ADDENDUM #2

NOTICE TO ALL BIDDERS FOR
CITY OF WINCHESTER

ITB #202005 – Valley Avenue Improvements

PROJECT	SHEET NO.
U000-138-R04	20(11)

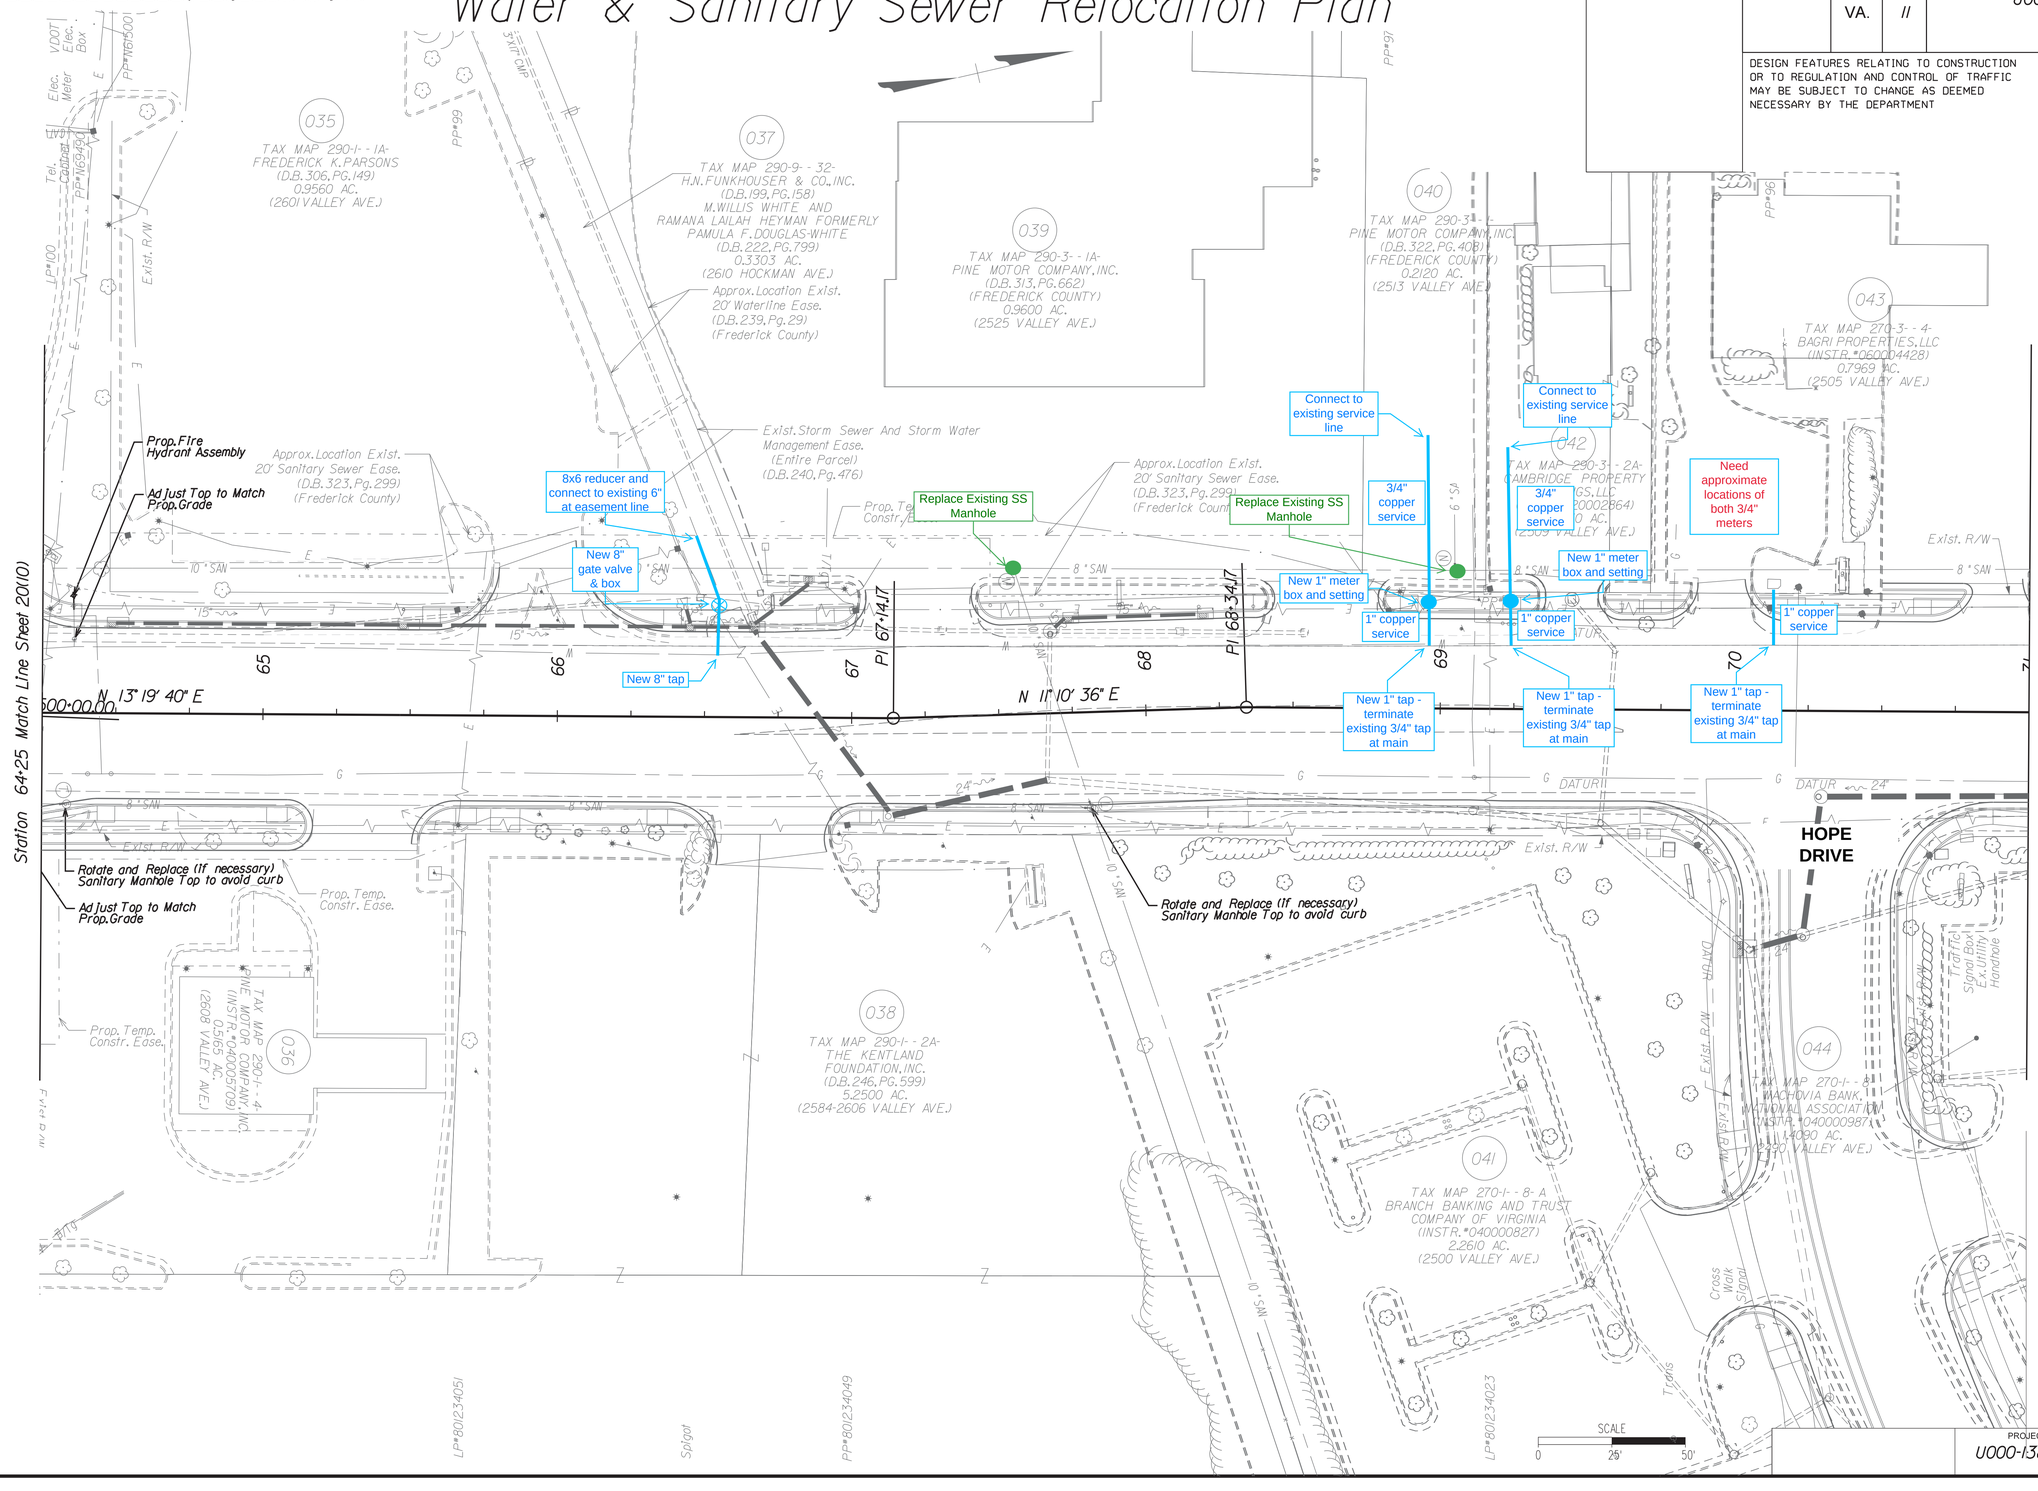
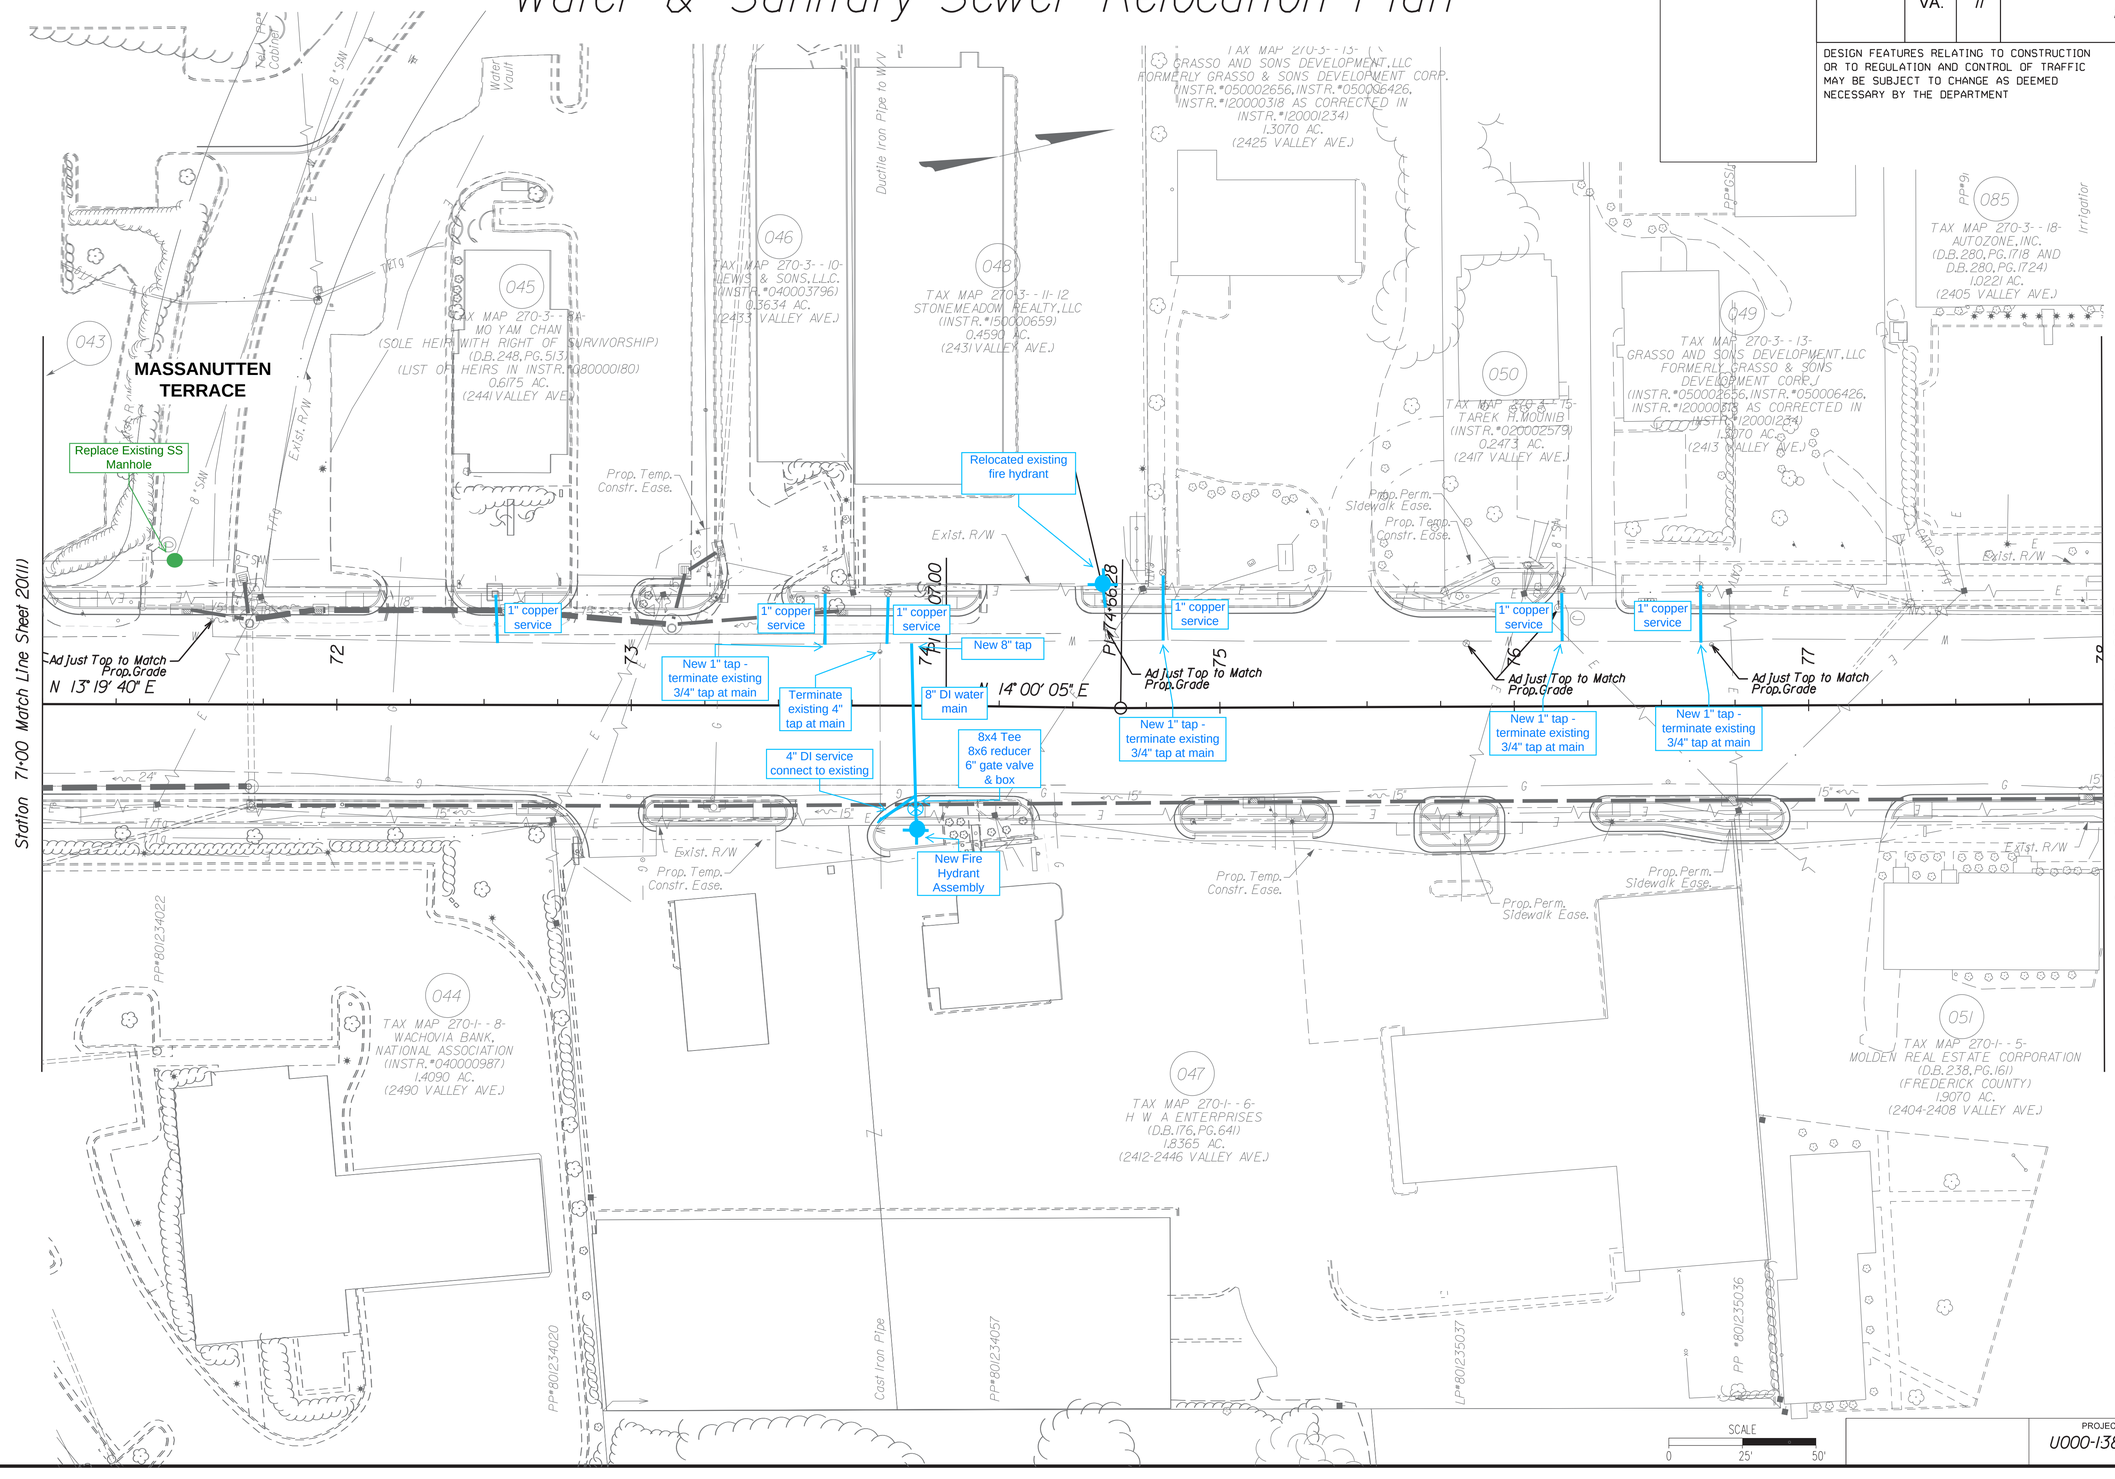
6. There have been numerous additions made to the water and sewer replacements for this project that are included in the revised Bid Form. The original plans have been modified with color showing this information and are attached.
